MOUNTAIN VIEW ACADEMY
CIVIL CONSTRUCTION DOCUMENTS
DETAIL GRADING PLAN

MOUNTAIN VIEW ACADEMY
CIVIL CONSTRUCTION DOCUMENTS
DRAINAGE DETAILS

CDs_V1.pdf Markup Summary

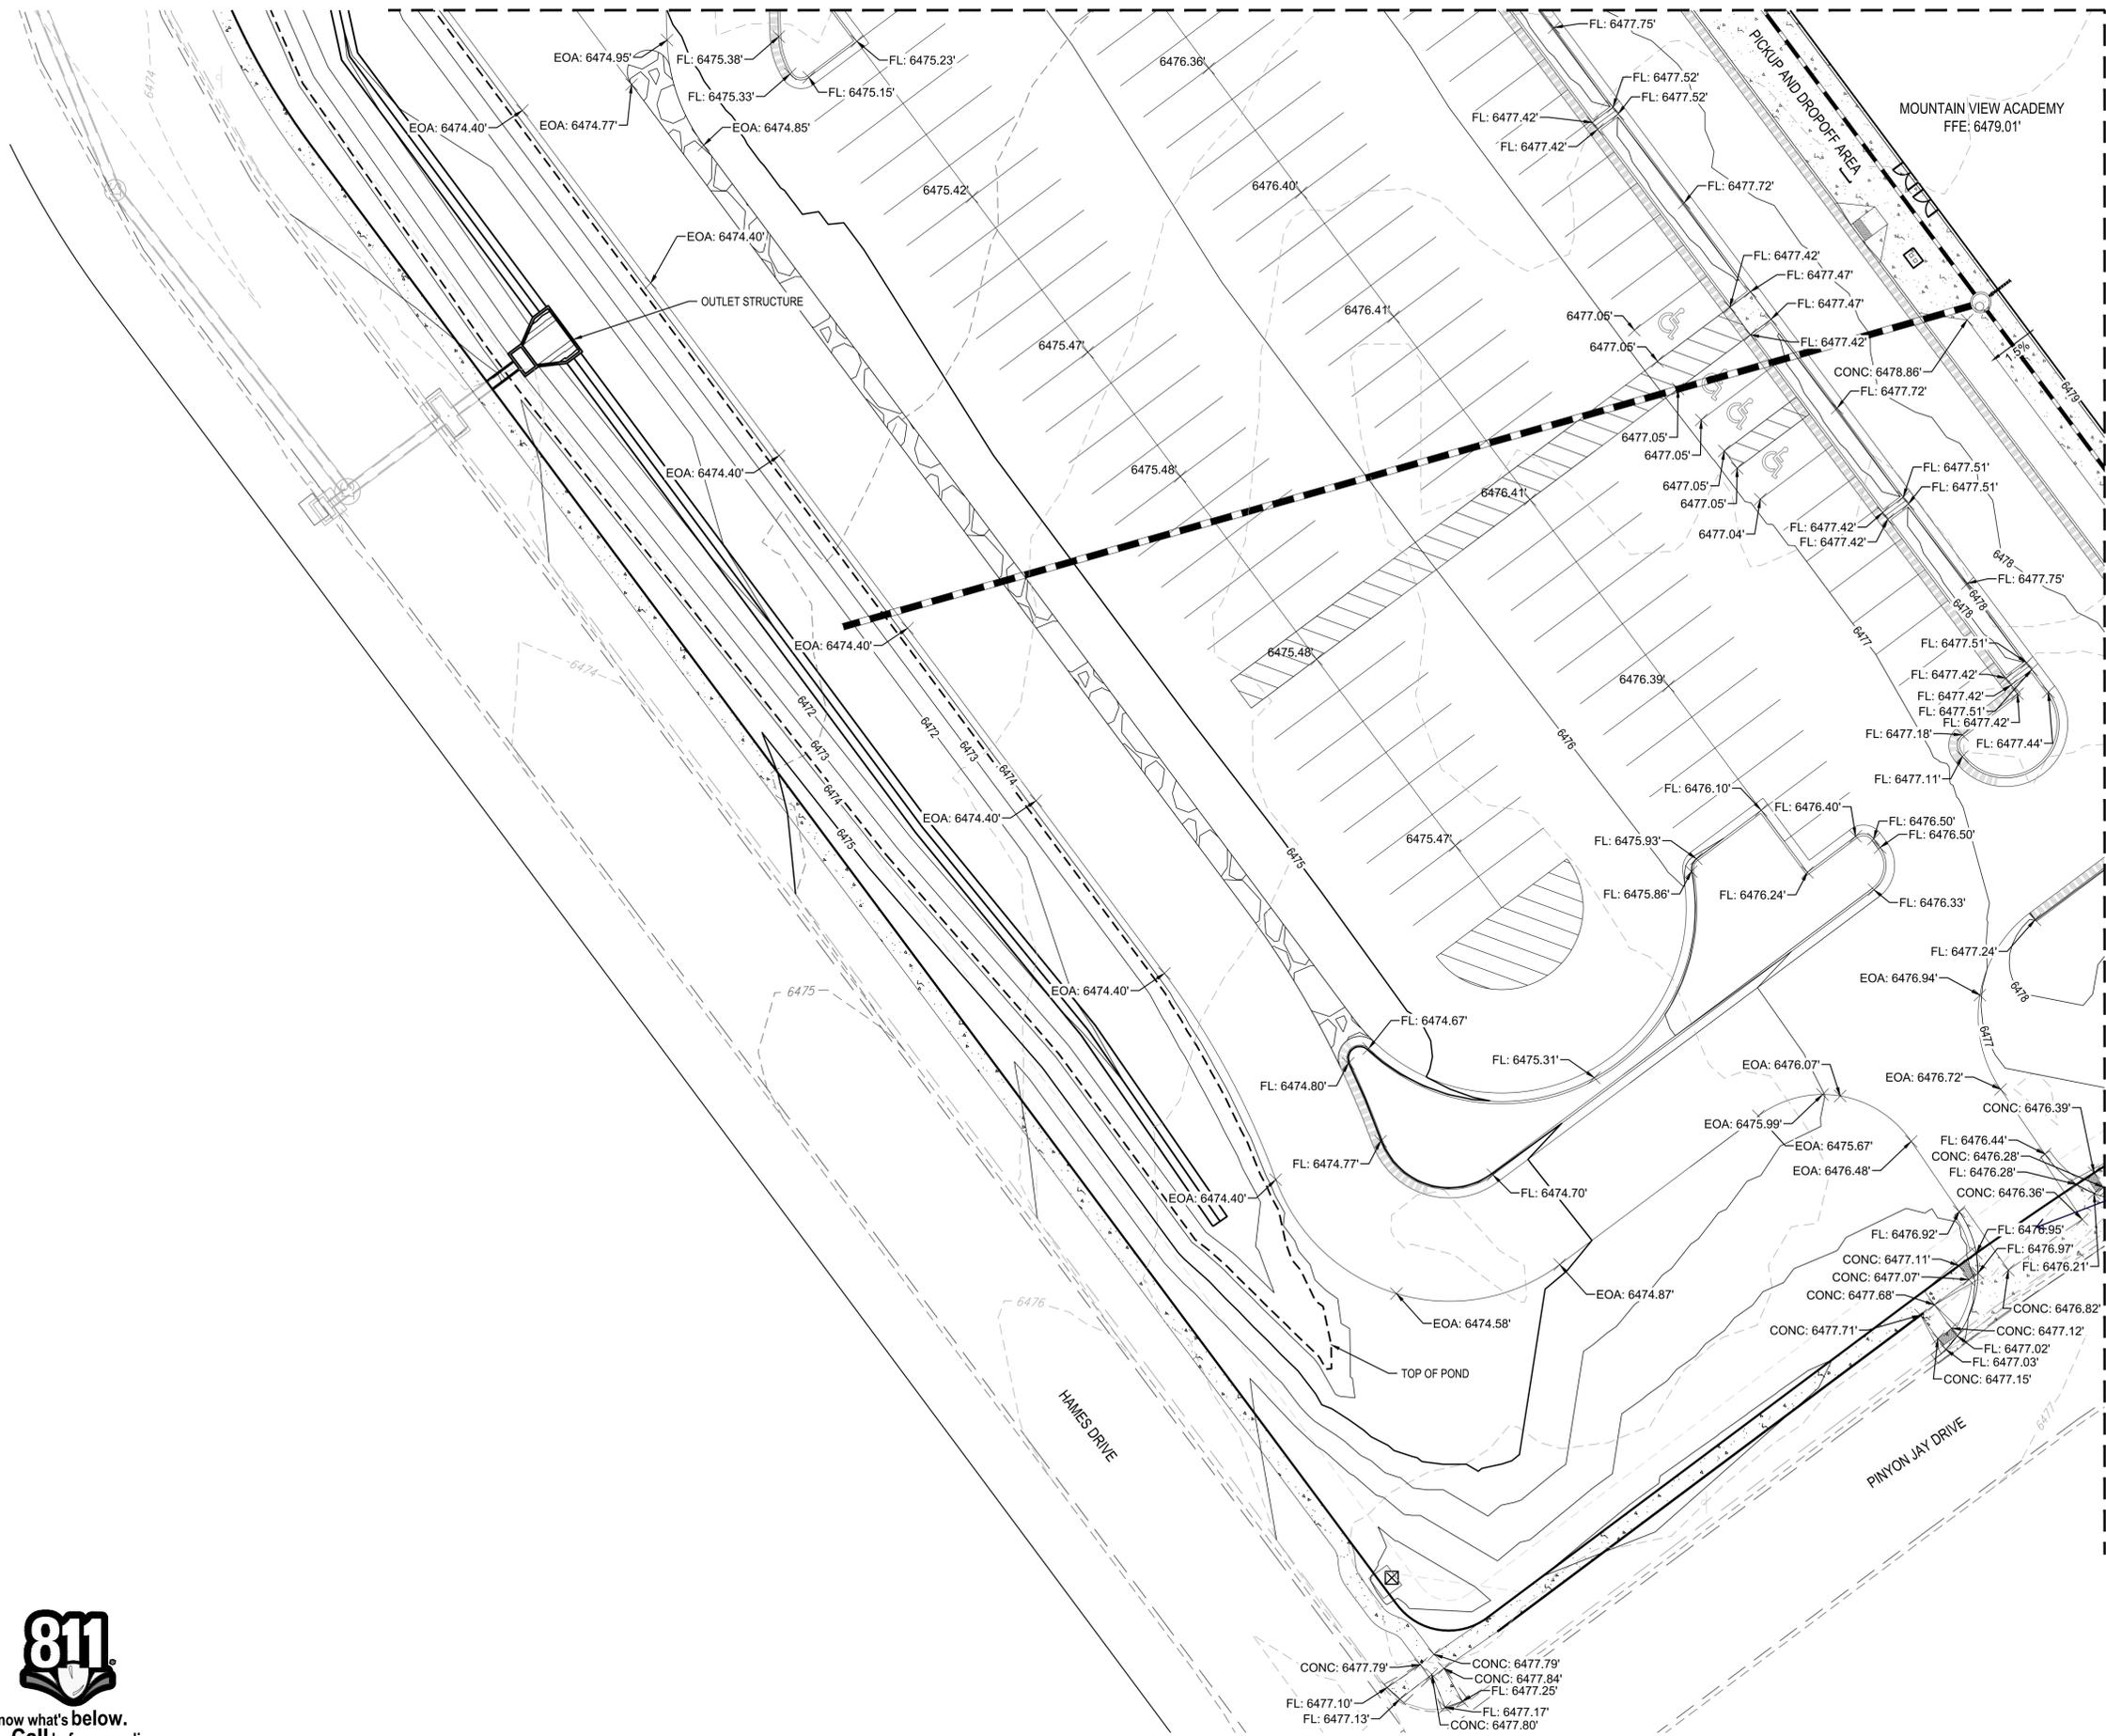
add slope tag. Slope be 2% or less along the pedestrian access route.

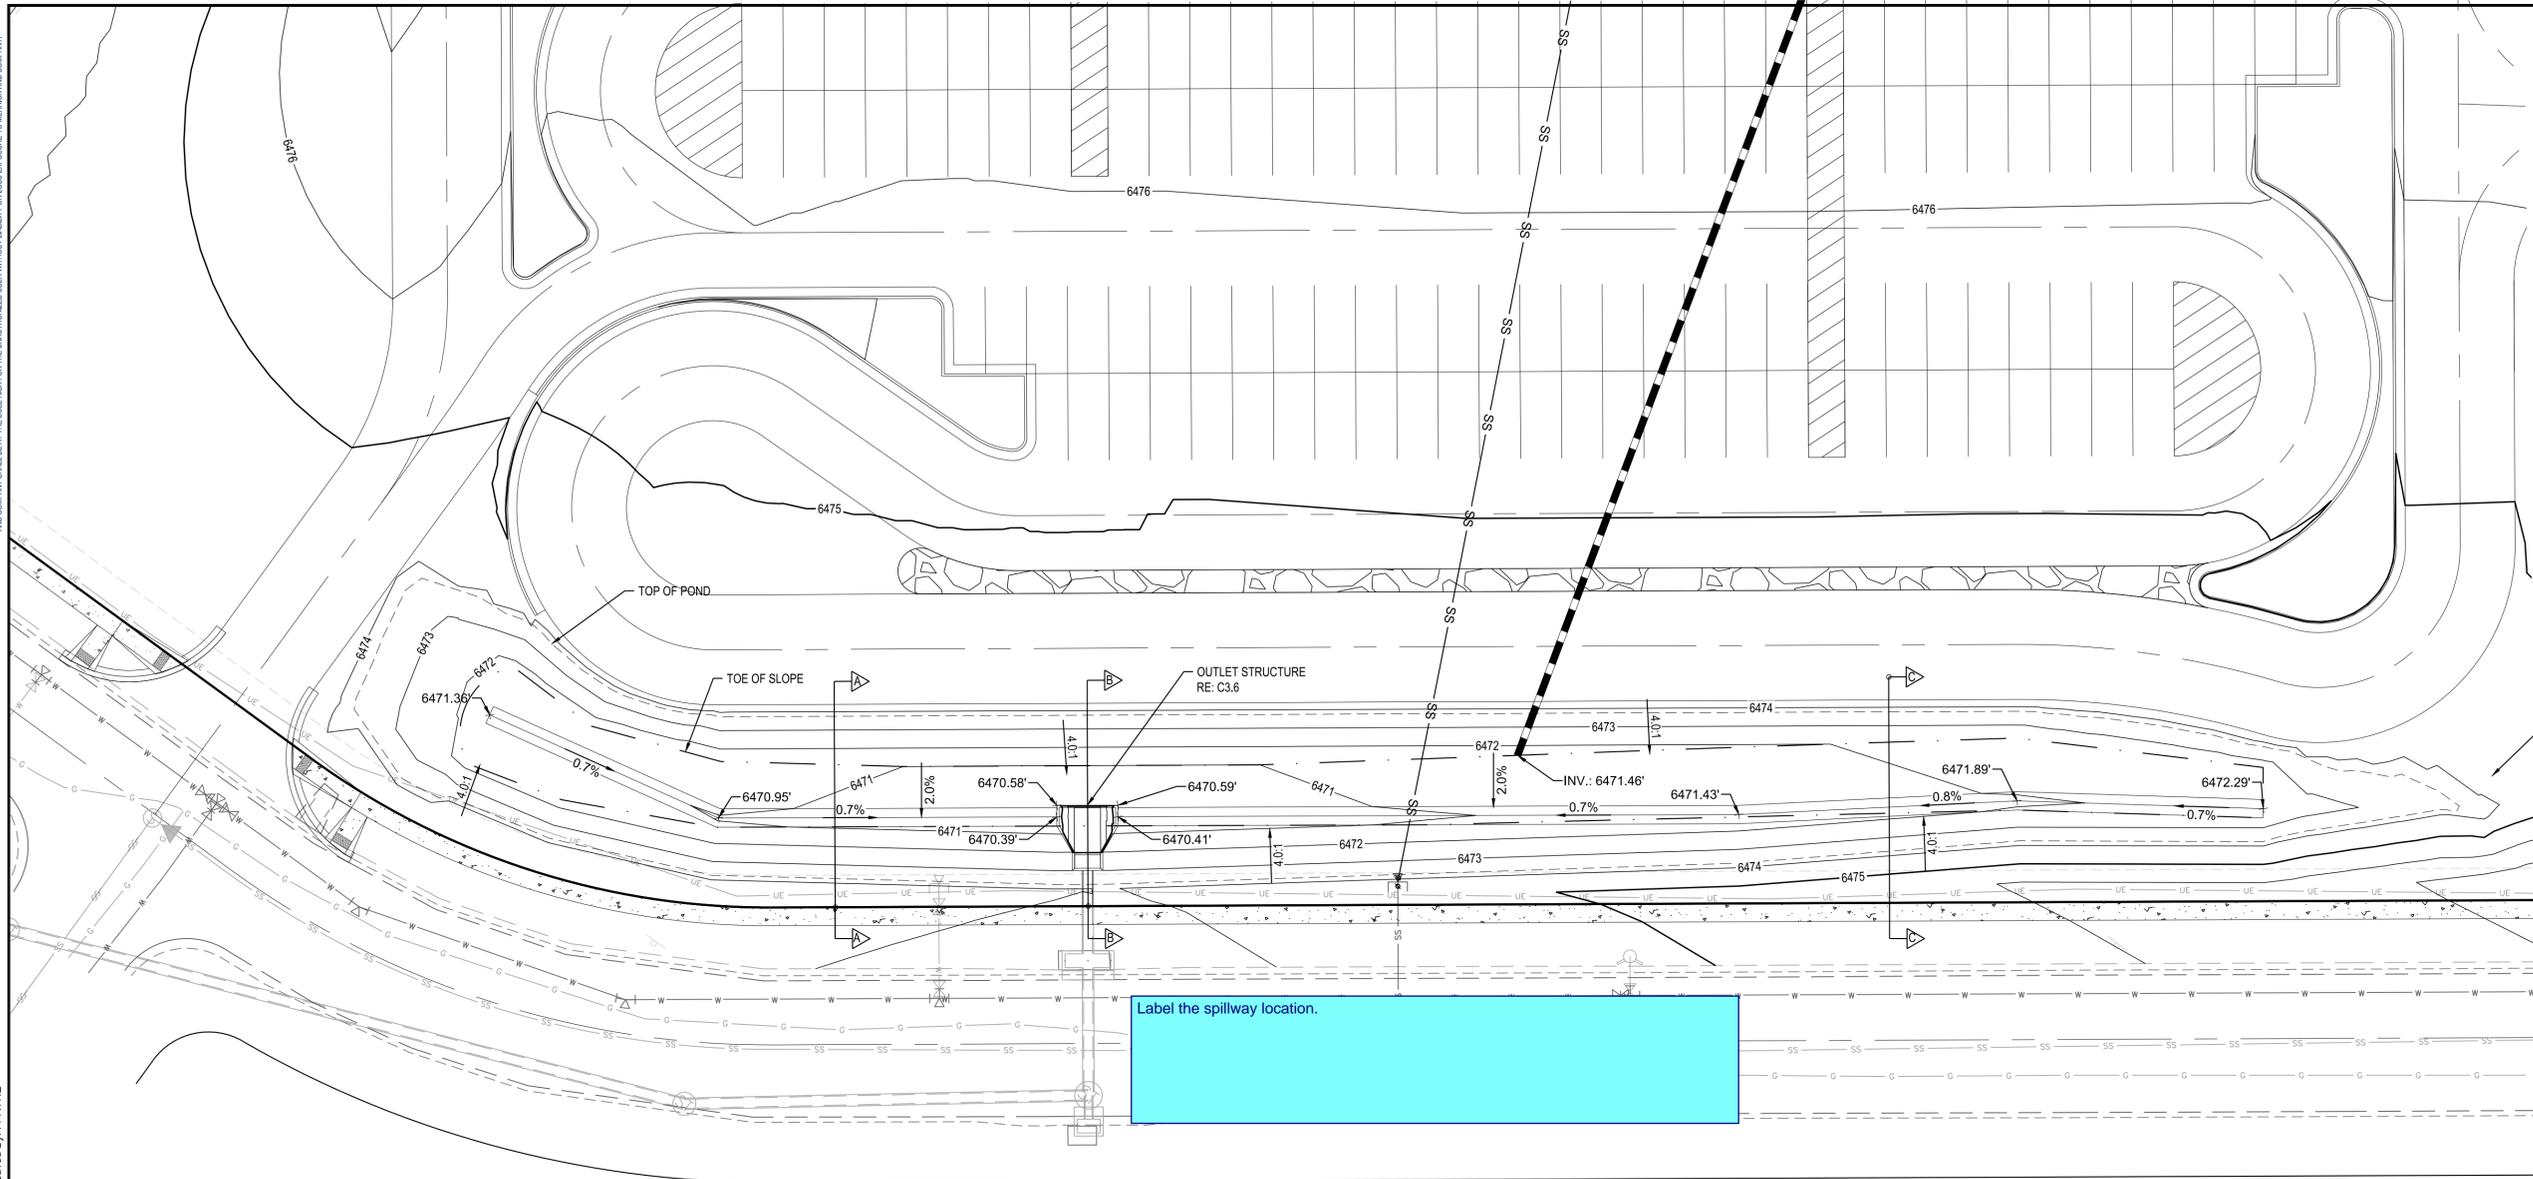
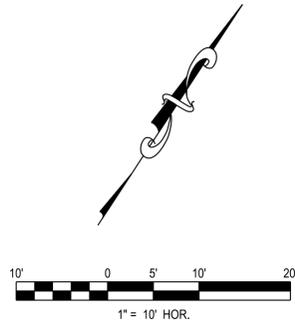
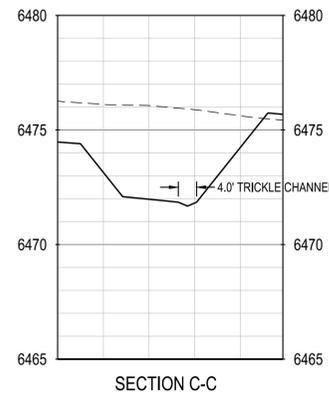
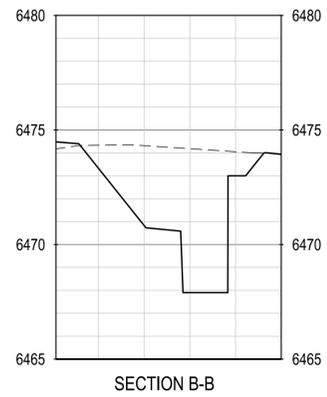
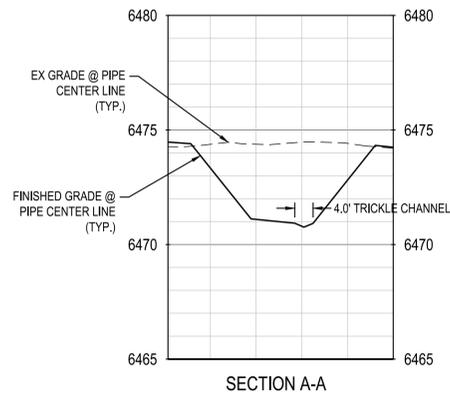
Pond design will be reviewed on the resubmittal. Pond design may be altered significantly based on comments in the drainage report.

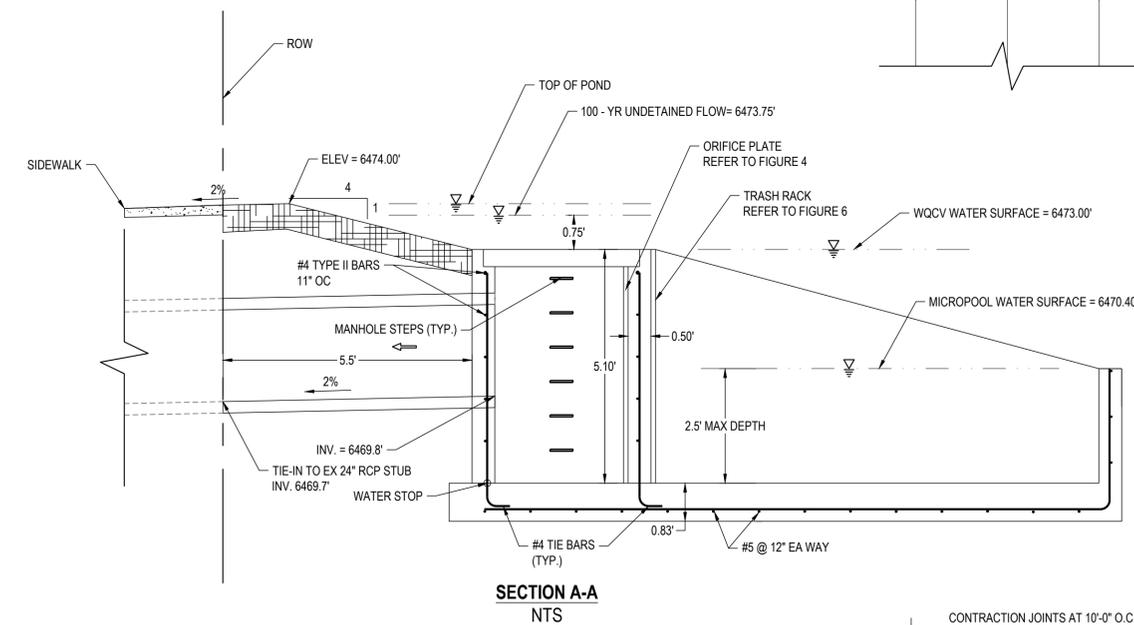
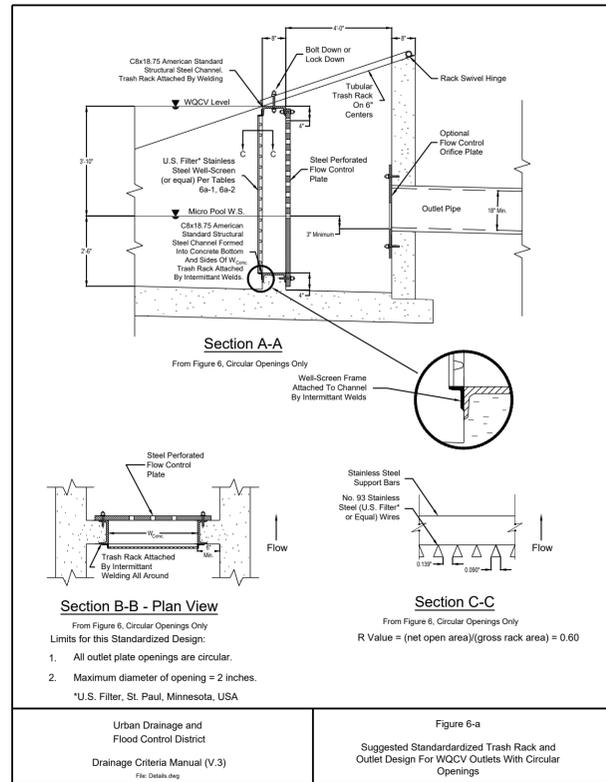
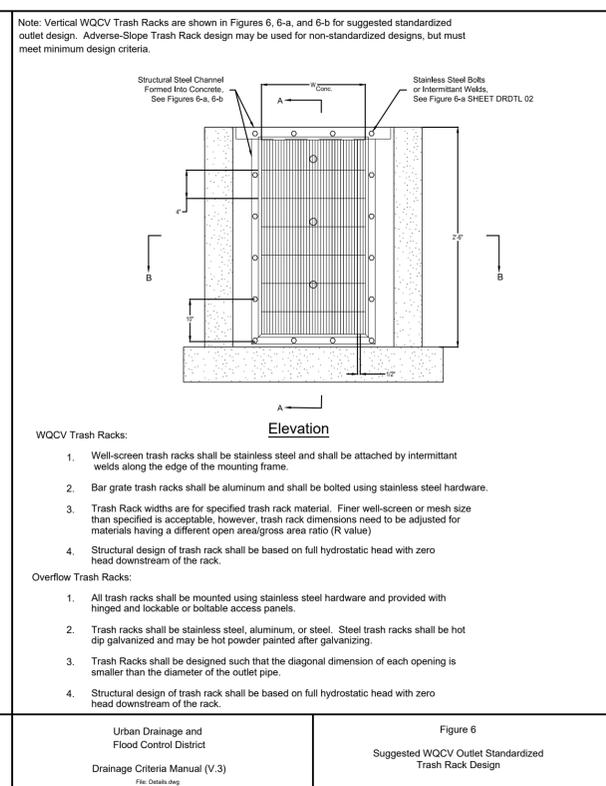
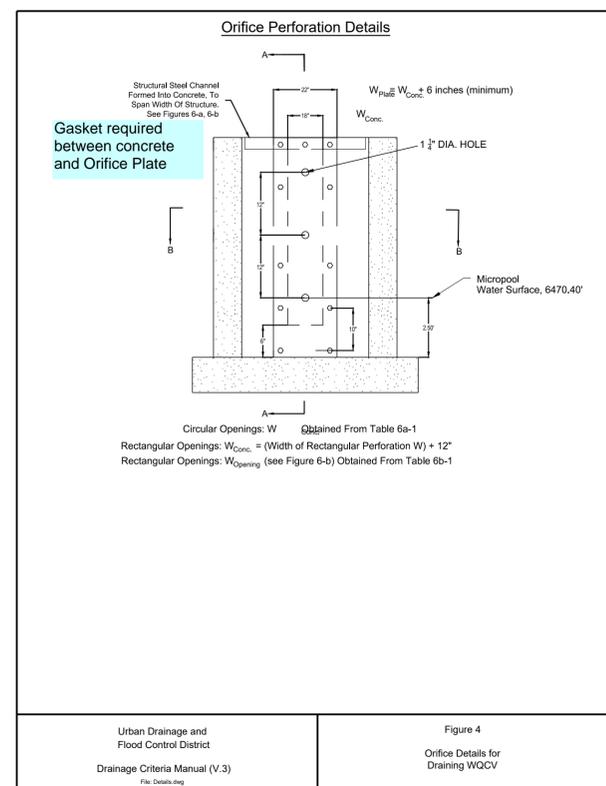
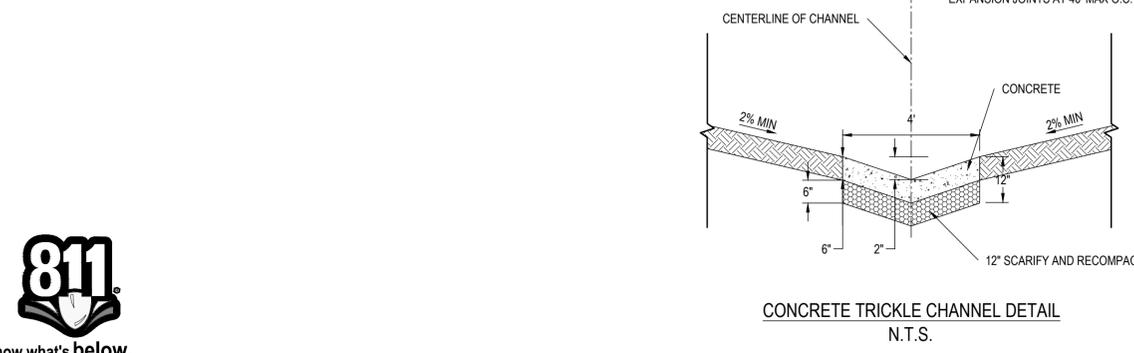
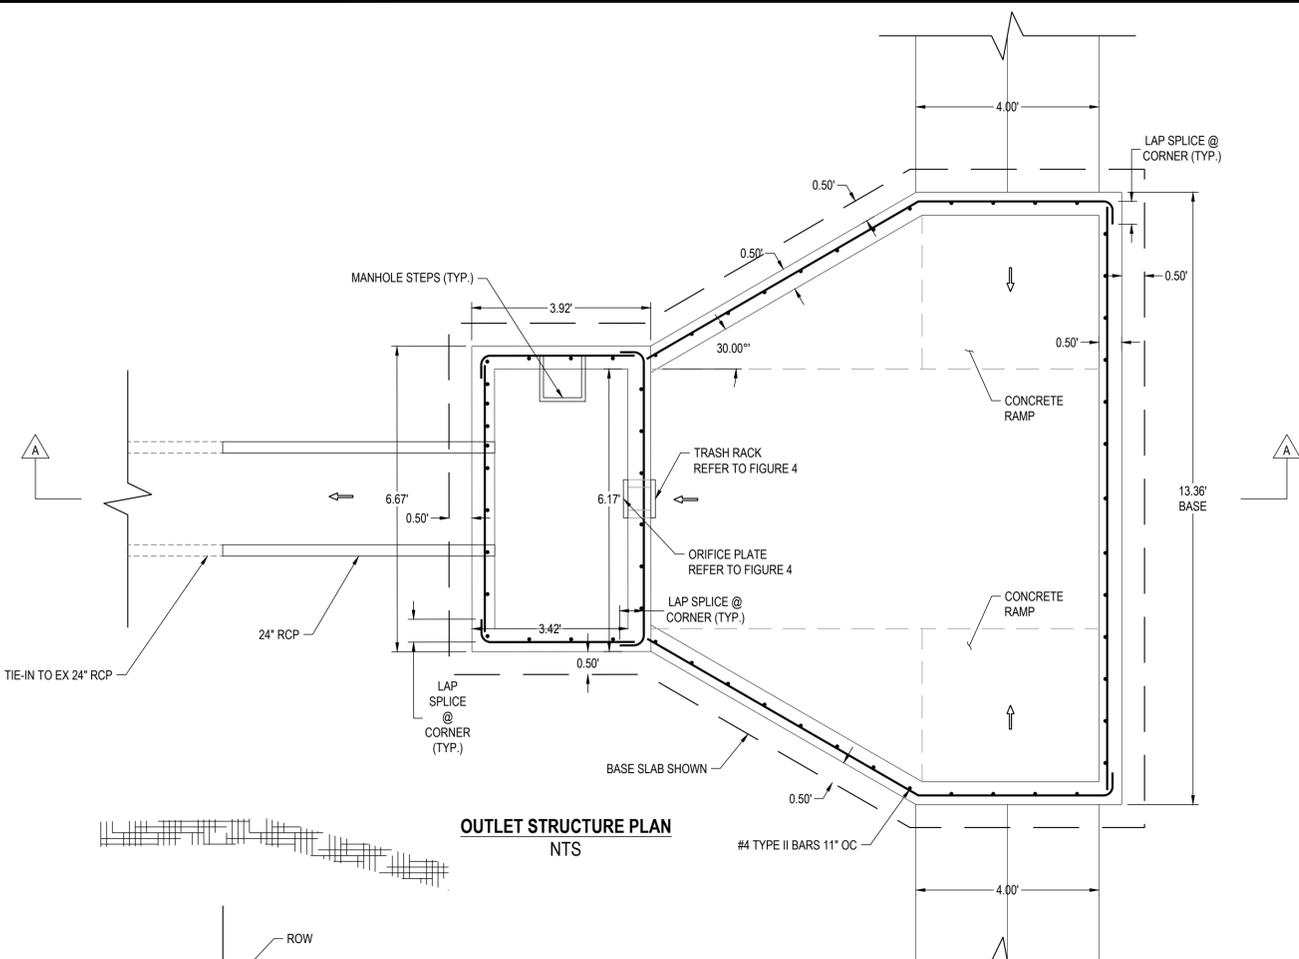
Limit details to 4 per sheet
